Contract E5L60
FAP No. 411665-2-582-01

RE: SR464 over CSX Railroad Unsuitable Materials Hearing

Re DRB - 0003

UNSUITABLE MATERIAL DISPUTE REVIEW BOARD POSITION PAPER

During Construction

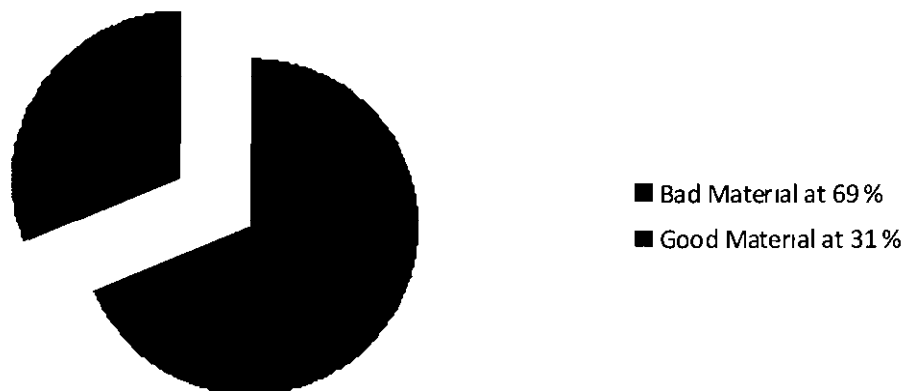
From reviewing the information in the geotechnical report, the following chart shows an "estimated" amount of material that was possibly good enough to use as embankment.

The results of the material sampled ranged from **A-3, A-2-4, A-2-6, A-2-7, A-6, A-7, A-7-5, and A-7-6**. The bold classifications are the same classifications as what was encountered in the original borings provided prior to the bid proposals. The other classifications shown are in the same group classifications differing typically in liquid/plastic limit thresholds. A-2-7 varies from A-2-6 similarly as A-6 varies from A-7 in the Liquid Limit Threshold. A-7, A-7-5 and A-7-6 are classified depending on the Plasticity Index Threshold (Exhibit 29).

From reviewing the information from the additional test samples that were taken in ponds 1A and 1B, the above chart shows an “estimated” amount of material that was possibly good enough to use as embankment.
